81532A-01A

S E R V I C E N O T E

81532A Power Sensor Module

Pilzferrule connector and Pilzferrule-style cable damage the lens of the power sensor

fig 1. Risk of lens damage when using a non-flat connector type.

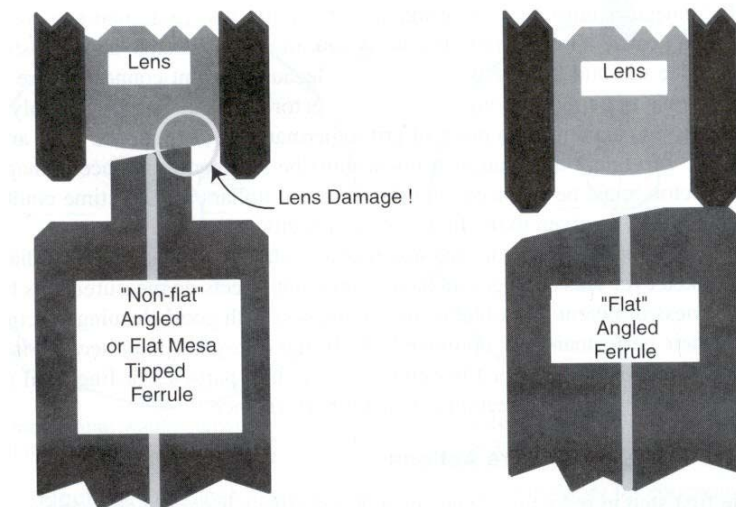
The 81531A, 81532A, and 81536A power sensors use a special connector with a lens interface to position the fiber end precisely to achieve very accurate power measurements from either a PC or a flat-angled connector. In this connector, there is a positioning sleeve to hold the end face at a known distance from the lens. However, if using a non-flat, Pilzferrule (mushroom ferrule), the fiber end hits the lens before the stop ring, (see fig 1).

DO NOT use non-flat type connectors, Pilzferrules types, with 81531A, 81532A, and 81536A power sensors.

fig 1. Construction details of a PC Pilzferrule (mesa or button) connector.

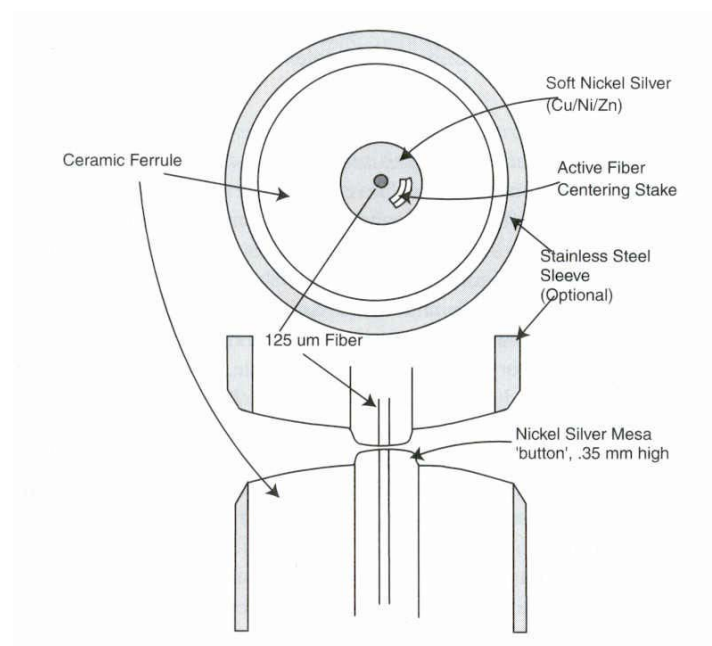
A so-called Pilzferrule, has a raised core in the ferrule producing a mesa or button-top on the end face, (see fig 2).
